We are writing this letter on behalf of our client, CB Maddox. Thank you for giving us the opportunity to sit down with you and Kris Klein to discuss the drainage issues relating to the Wedge Meadows Subdivision ("Wedge Meadows") and the construction of Wedge Parkway and Arrowcreek Parkway. Per our April 25th, 2005 meeting I am writing you this letter to clarify what we feel are possible solutions to the drainage issues created by the re-alignment of Wedge Parkway and the placement of related culverts.

To: Kristine Klein, P.E.
From: Mary Horvath, P.E.
CC: Cary Chisum, P.E.; CB Maddox

This memo is essentially the same as the one submitted to Washoe County in July 2004 with minor revisions for increased clarity. It is meant to outline the assessment by Wood Rodgers of the hydraulic conditions of Reach 3 of Whites Creek in the vicinity of the Arrowcreek/Wedge Parkway intersection prior the construction of the roadways. This was done to estimate the quantity of flow that would have reached the Phase VI Wedge Meadows property pre-construction in the statistical 100-year flood event defined as 3000 cfs within Reach 3 of Whites Creek. This memorandum references the figures I provided in

No. 9147 P. 17

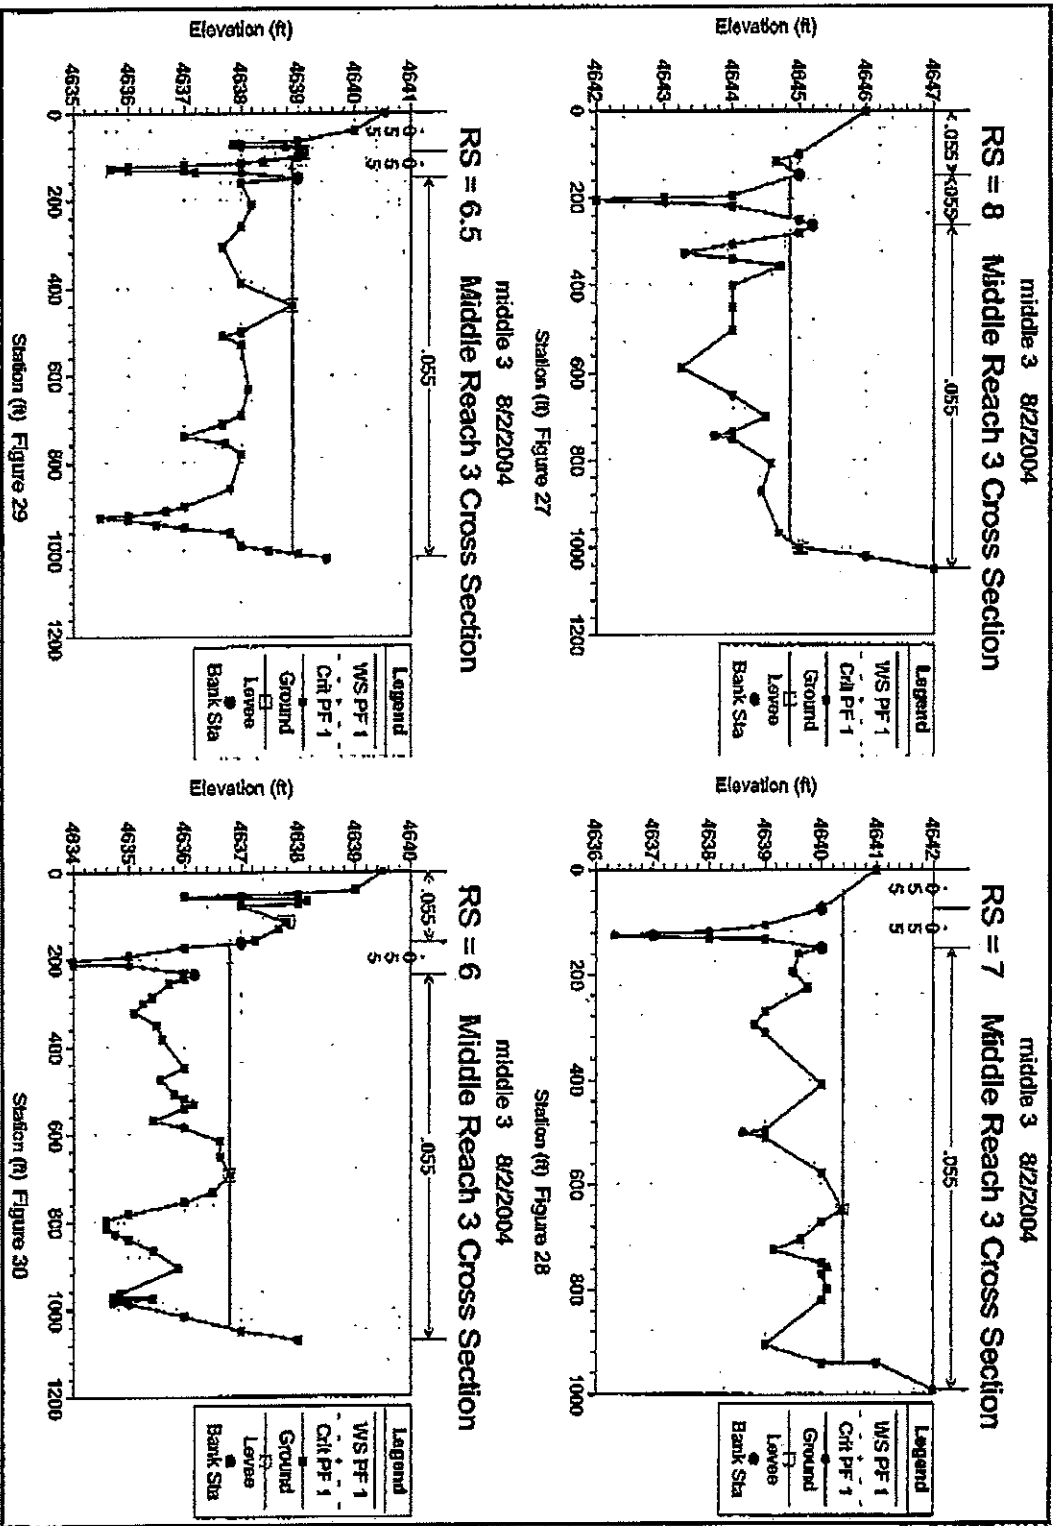
It is our opinion that the cross section placement and orientation in WRC's existing conditions model do not accurately depict flood flow conditions. The cross sections are aligned so that from left to right looking downstream they extend from high to low elevations so that the majority of the flow area is in the right, or southern, portions of the cross sections. As a result of this distortion, the main flow path of Reach 3 along the left side of the floodplain (that was observed flowing during the early summer of 2004) is modeled to be dry or near dry in the 3000 cfs event.

However, since this is what was used for the roadway design, we first used this model for evaluation of Reach 3. Because we could not locate a digital copy of the HEC-RAS model, we replicated the cross sections from the printouts within the WRC report and ran the model with 3000 cfs steady flow. The results matched WRC's results within 0.10 feet for each cross section. We used the flow distribution option within HEC-RAS to compute the quantity of flow within subdivisions of each cross section. The results are presented in Figures 1 through 10. Figures 1 through 9 show the cross sections going from upstream to downstream with the approximate flow distribution (orientation is from left to right looking downstream). Figure 10 shows the plan-view layout of the pre-project WRC model with the numerical flow distribution shown in red for each cross section. The majority of the 3000 cfs is distributed within the right or southern portions of the cross sections in cross sections 9 through 2. Cross section 1 is shorter than 2 through 9 so that it cuts off the flow paths within the southern portions of floodplain, forcing the majority of the flow to be within the center of the cross section and putting more water in the left side and forcing the floodplain to extend to the north.

- Figures 11-14: WRC's post-project HEC-RAS model cross sections showing the 3000 cfs flow distribution through the culverts as computed by HEC-RAS (replicated by Wood Rodgers).

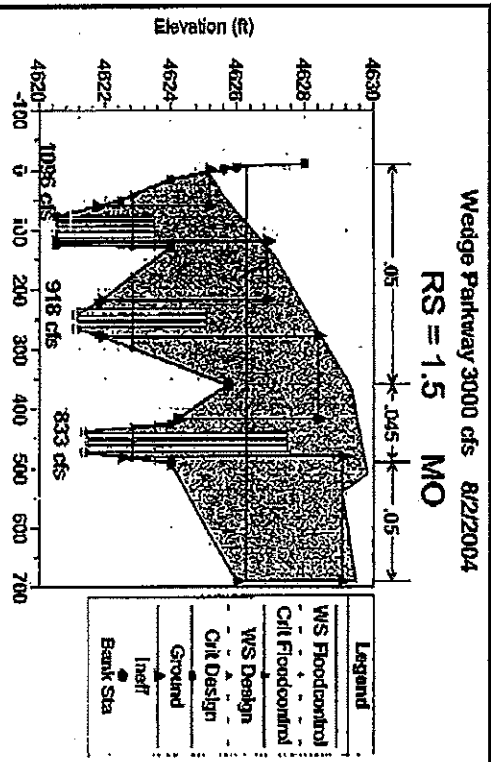
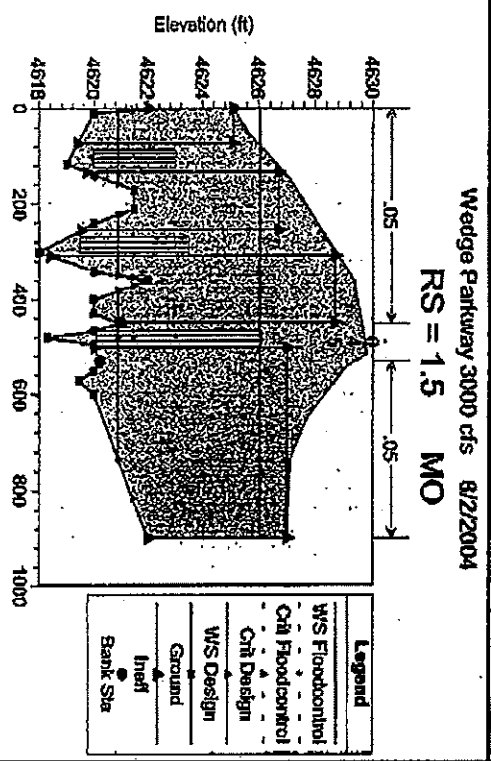
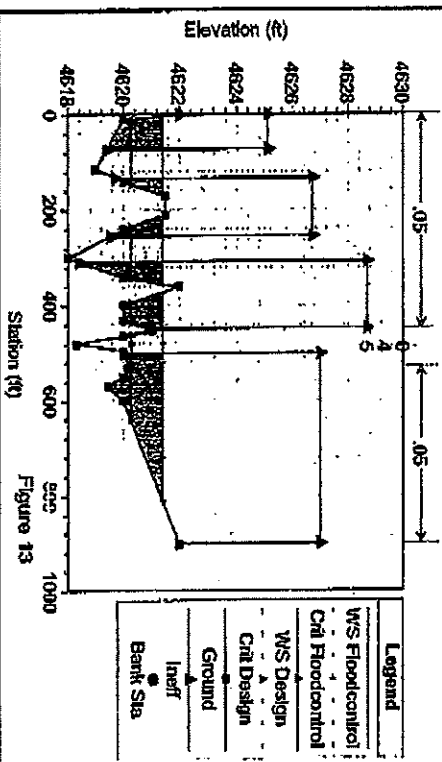
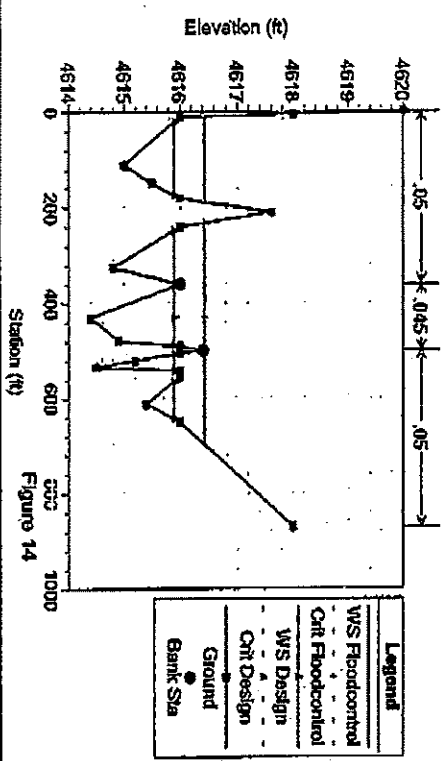
To analyze the effect of the roadway and culvert construction, we re-created the post-conditions HEC-RAS model with the three culverts using the existing topography available from the City of Reno DataNavigator and the alignment of the cross sections from the WRC report. Because the alignment of Wedge Parkway travels up the alluvial fan from north to south, the lowest part of the road is near its intersection with Arrowcreek Parkway. The WRC report states that because the upstream portion of the roadway is at-grade, approximately 500 cfs would weir over the roadway in the southern stretch of Wedge Parkway in the 3000 cfs event. We also believe that there are discrepancies with this evaluation. Wedge Parkway was not constructed completely at-grade in this section; water would have to pond to depths of near a foot before weiring over the road. The shallow sheet flow on the alluvial fan would instead most likely flow north to the culverts that were constructed at the lowpoint of the roadway just south of the intersection of Wedge Parkway with Arrowcreek Parkway. To simulate this, we neglected the subtraction of the 500 cfs from the 3000 cfs in our post-construction model.

A multi-cell box was constructed approximately 500 feet south of the intersection of Arrowcreek and Wedge Parkways to perpetuate the alignment of the main channel and overflow culverts were placed north of the main channel. According to our replication of the WRC pre-project modeling, this is not where the majority of the flow was conveyed in pre-construction conditions. Figures 11 through 14 show the recreated post-construction cross sections of the crossing of Wedge Parkway with the flow distribution of the culverts shown in Figure 11. In the 3000 cfs event, the farthest left culvert conveys 1096 cfs. This flow plus a portion of that conveyed by the middle culvert will flow directly to the Phase VI Wedge Meadows site. We believe that the placement of the culverts effectively changed the course of a large portion of the Reach 3 flood. Previously, according to the WRC pre-construction model, the majority of the flow was conveyed along the right or southern portion of the floodplain. The construction of the roadway and culverts forces the flow to be concentrated in the north and directs a large quantity to flow directly north to flow to the Phase VI site. Even if 500 cfs were to weir over the southern portion of the roadway, the northern and middle culvert would still convey a large portion of the 3000 cfs.
